City of Santa Fe, New Mexico

2051 CERROS ALTOS TERRAIN MANAGEMENT VARIANCE

Case #2016-06. 1503 Cerros Altos Terrain Management Variance. Sommer, Karnes and Associates, LLP, agent for Julie Silverstein Trust and the Kim M. Colweck Trust, requests a variance to the Terrain Management Regulations (Subsection 14-8.2(D)(3)(b)) to construct a single family residence. The applicant is requesting a variance to have more than one-half of the building footprint in natural slopes of greater than 20%. The property contains both Foothills and Ridgetop Subdistricts of the Escarpment Overlay Zone. The property is 4.337 acres and is zoned R-1 (Residential – 1 unit per acre). (Katherine Mortimer, Case Manager)

Exhibit D
Photo Renderings

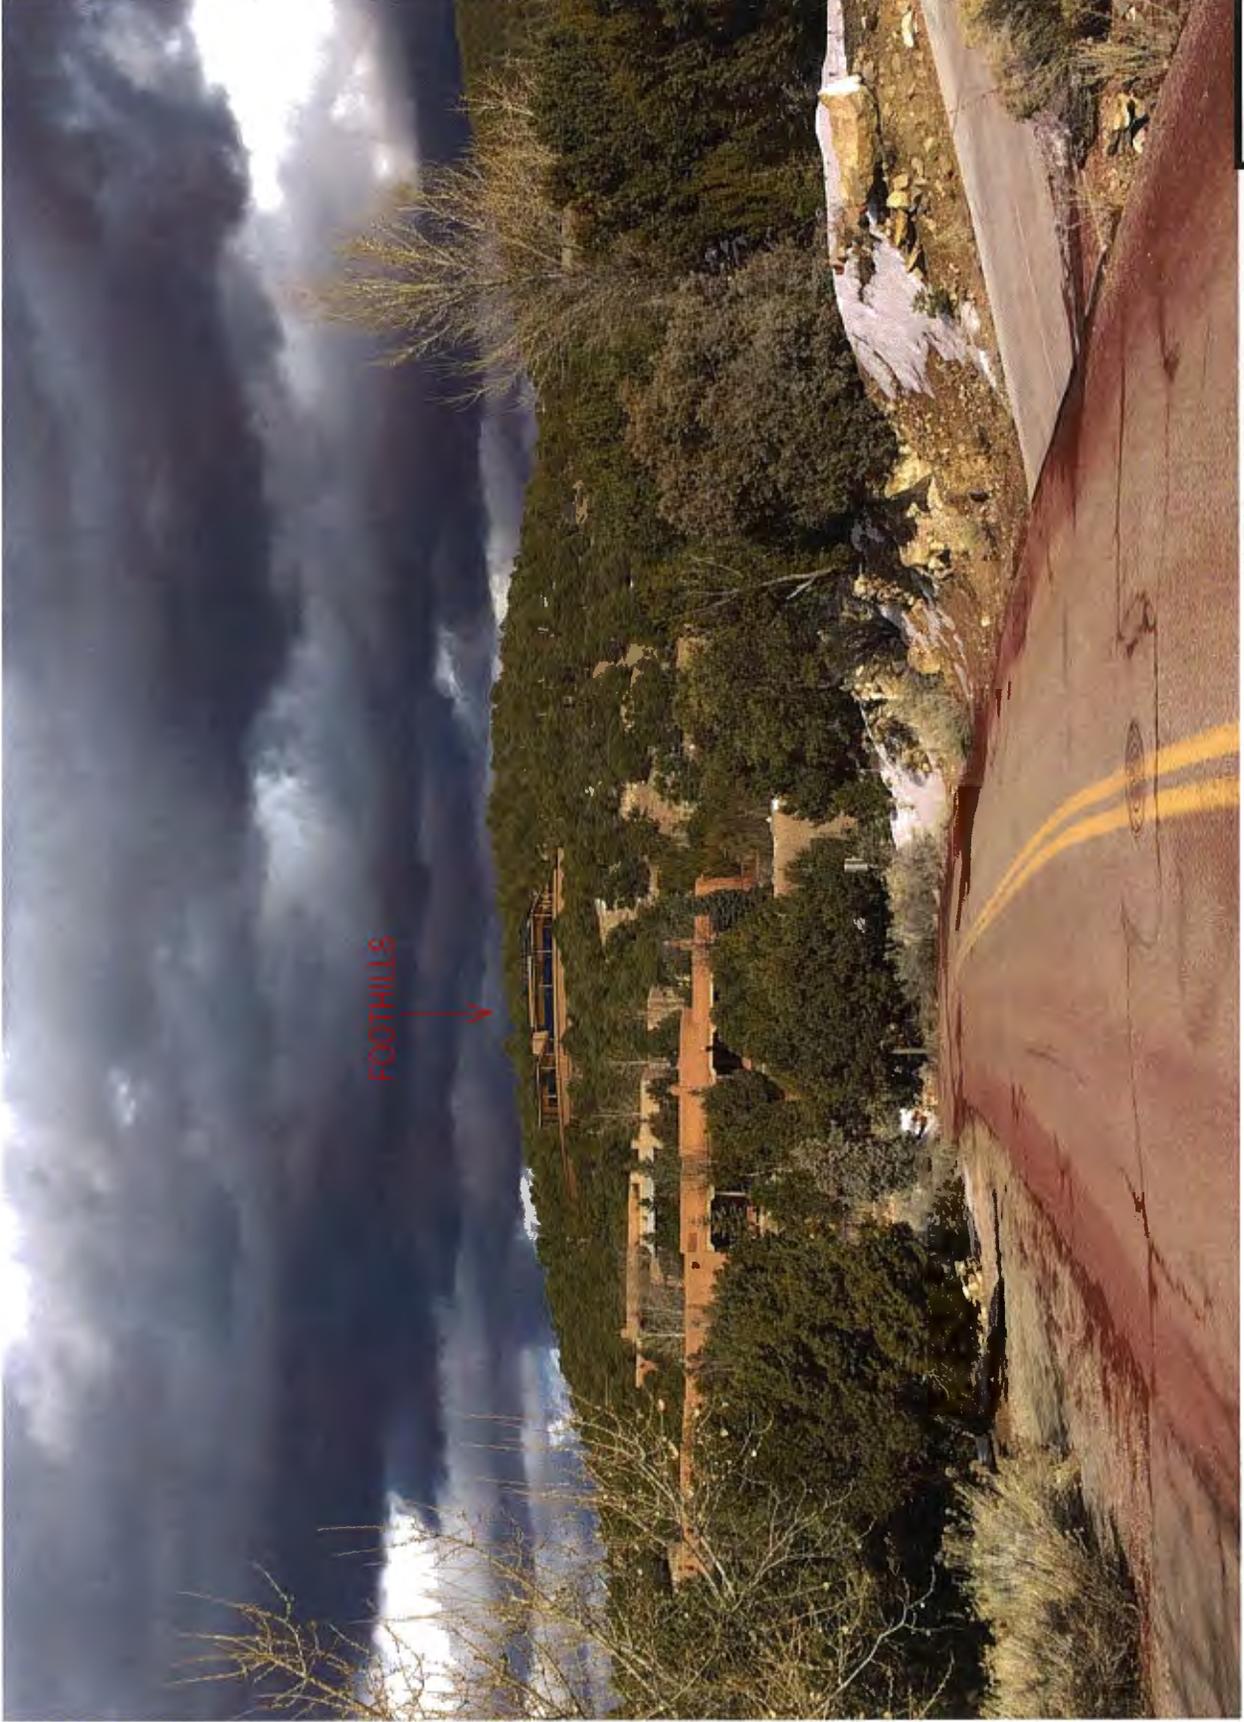
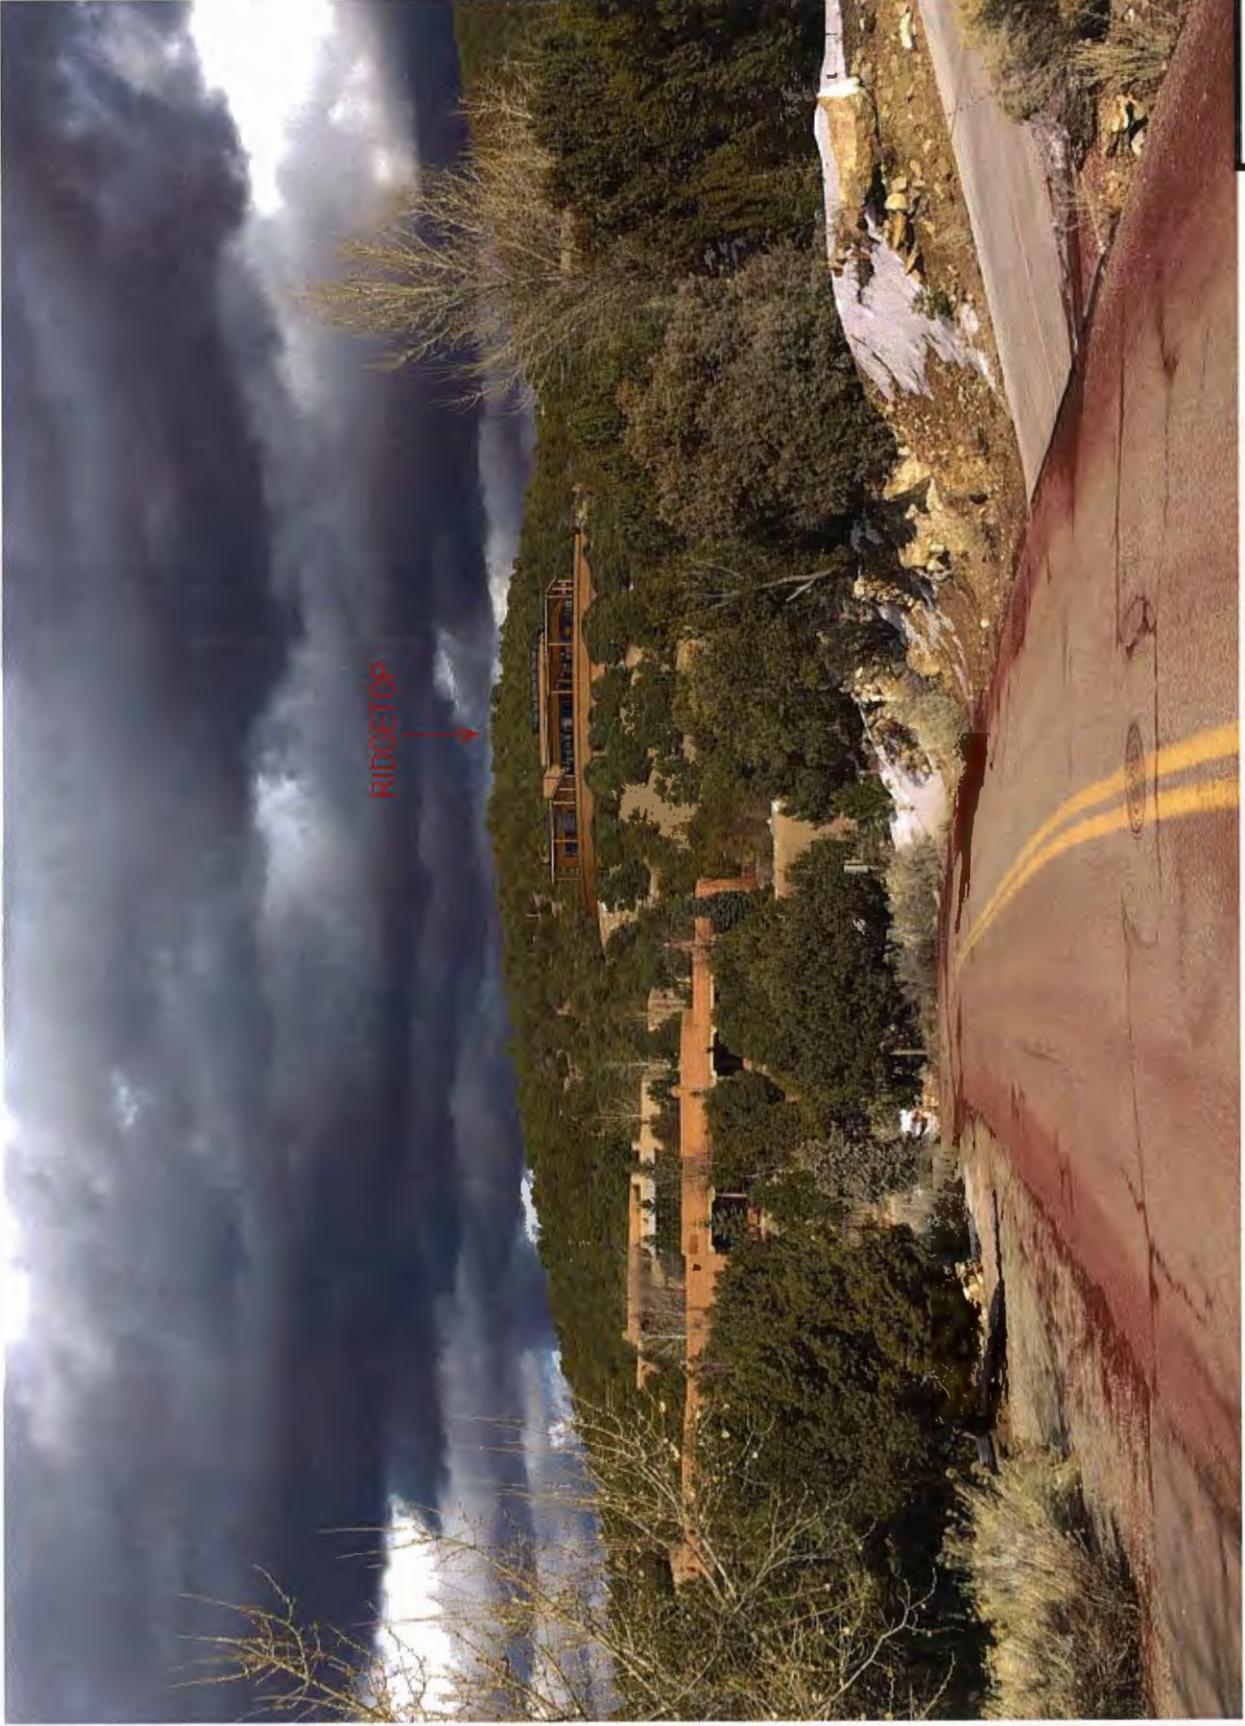
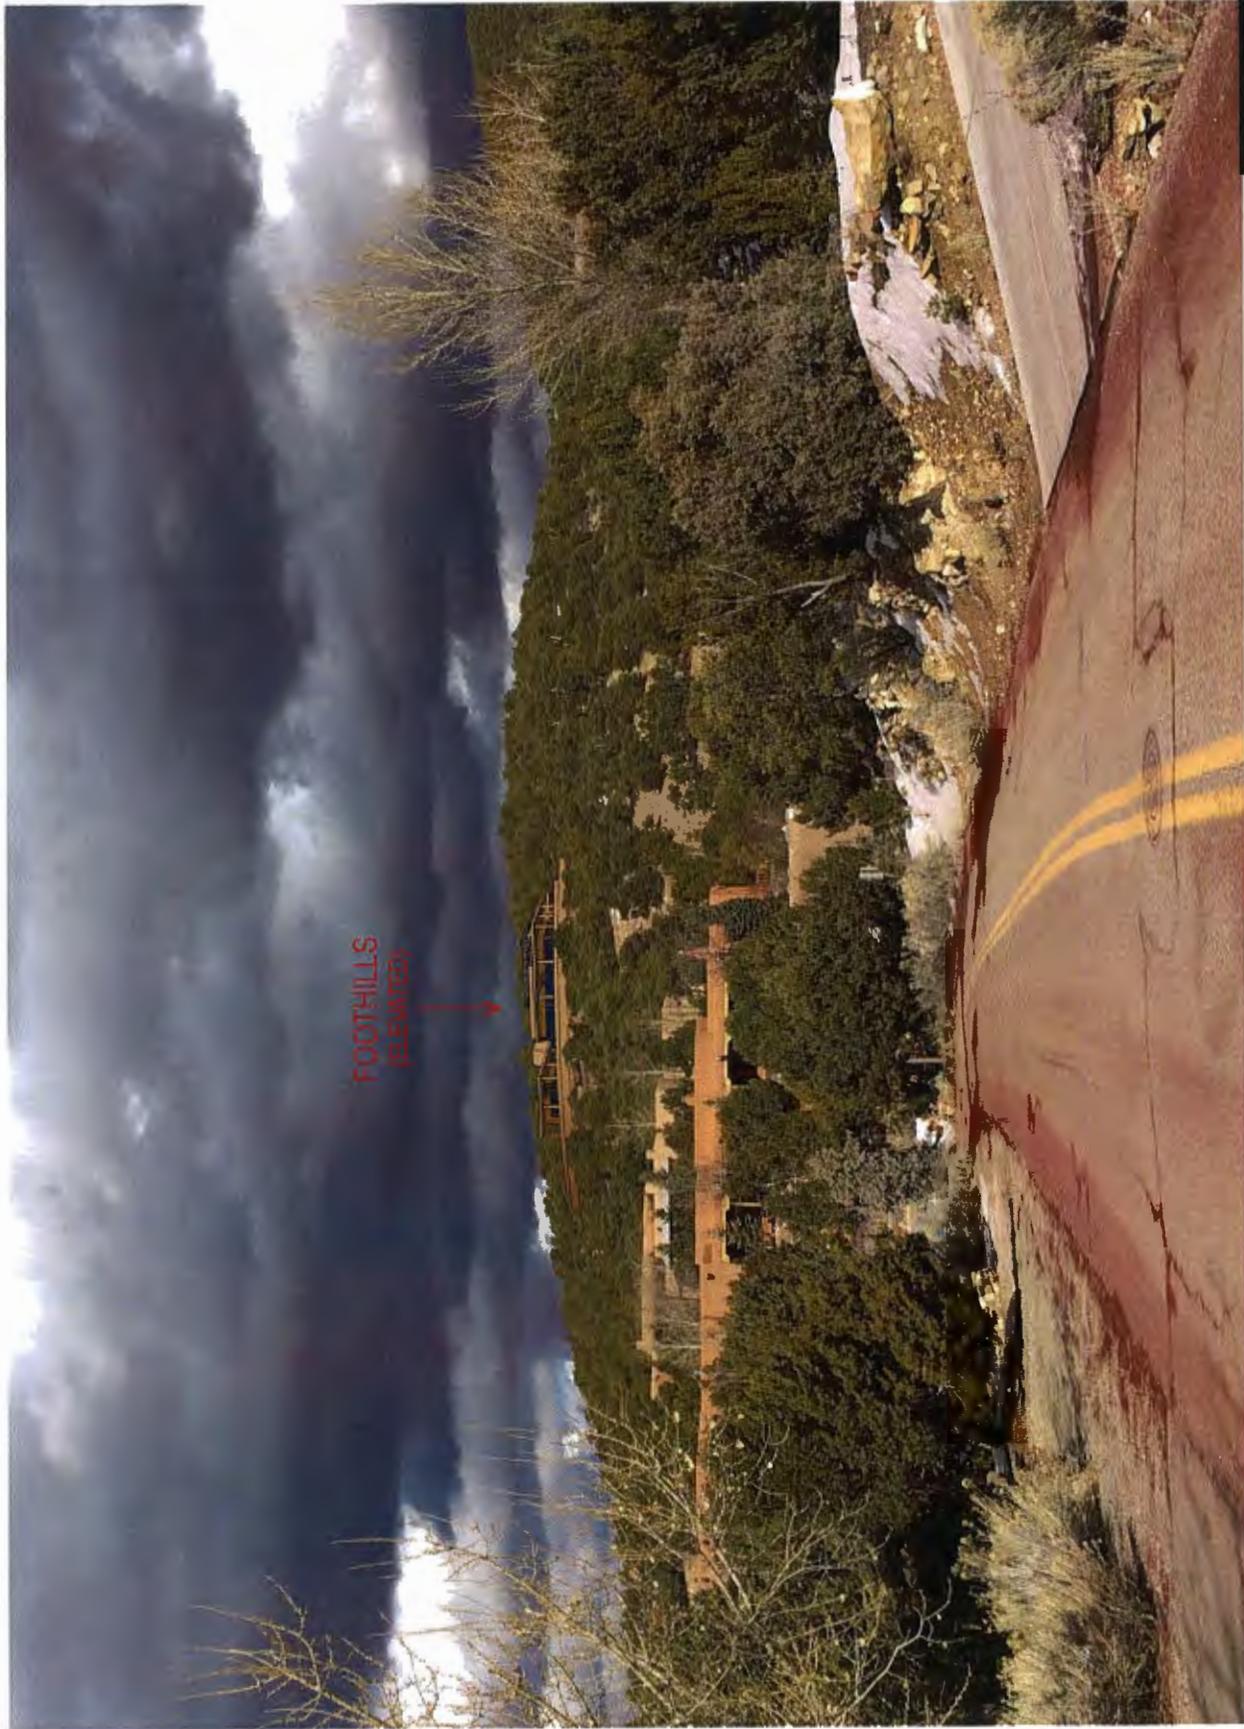
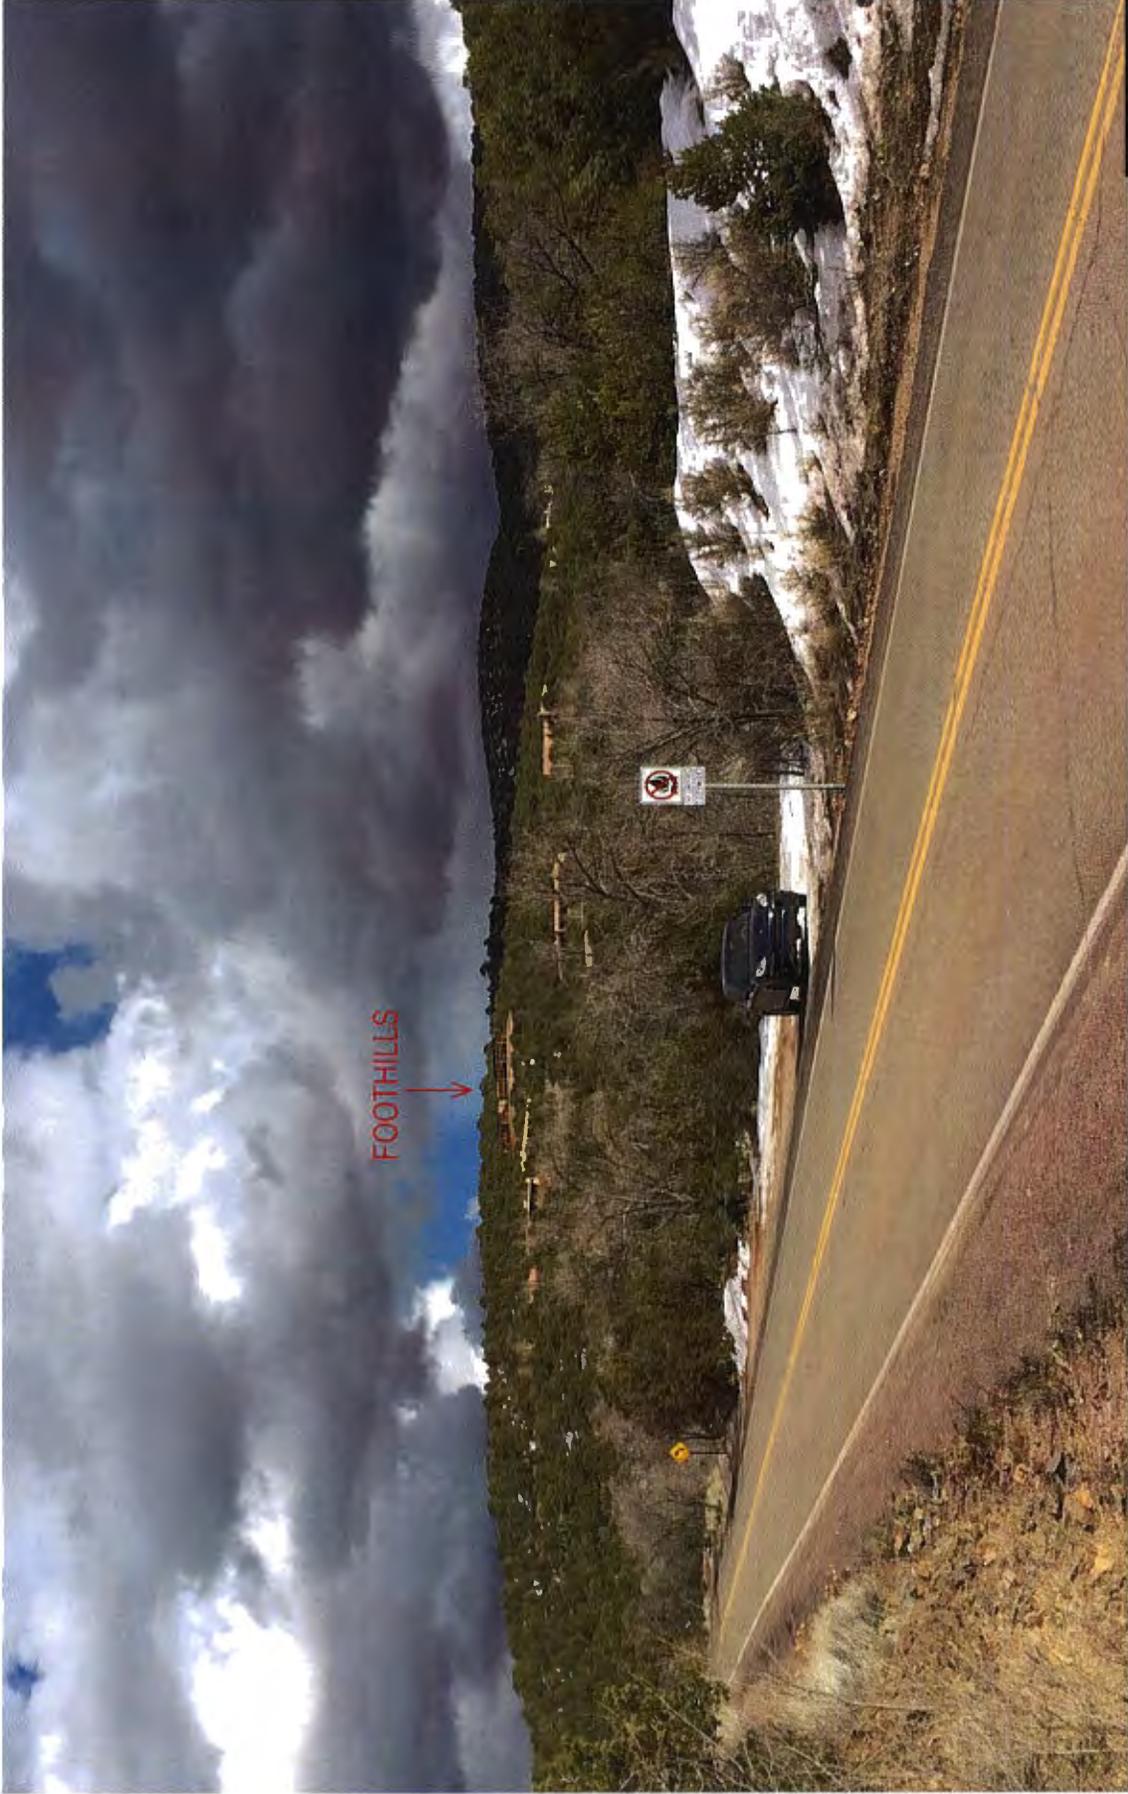
The applicant has provided photo renderings comparing the proposed location to an alternate location, as viewed from the two public roadways where the site is visible. (See Exhibit D) The alternate location would shift the footprint onto a flatter part of the site – avoiding the "50-50" variance – but would encroach into the Ridgeline Subdistrict. The renderings show that the home would not visually break the plane of the ridgeline as seen from public roads if located on the proposed location (Foothills). At the Ridgetop Subdistrict location, the home would visually extend above the ridgeline when viewed from Hyde Park Road. The proposed siting of the building is located away from the viewline as directed by SFCC §14-5.6(D).

Exhibit D includes photo renderings of the proposed home if it were moved northward to reduce the percentage of the footprint located on slopes less than 20%. These demonstrate that development on this site would result in public views of the building where the home would visually extend higher than the plane of the ridgeline, which is contrary to the intent of the Escarpment Overlay District.

If the building were moved northwards into the portion of the buildable area with slopes under 20% it would reduce the amount of the building footprint on slopes greater than 20% even if it wouldn't achieve a 50-50 ratio as required by the terrain management regulations. However, it would increase the overall amount of grading on the site and would increase the height of the top of the building and, as noted earlier and demonstrated in Exhibit D, would result in greater visual impacts conflicting with the intent of the Escarpment Overlay Zone.

Therefore, while moving the building to the north would technically reduce the amount of variance requested, it may be less in keeping with the full range of intent of the code when considering the escarpment overlay purpose and intent.

terrain management impacts. The photo renderings show that were an escarpment variance be granted, the home would not meet the intent of the Escarpment Overlay Zone.
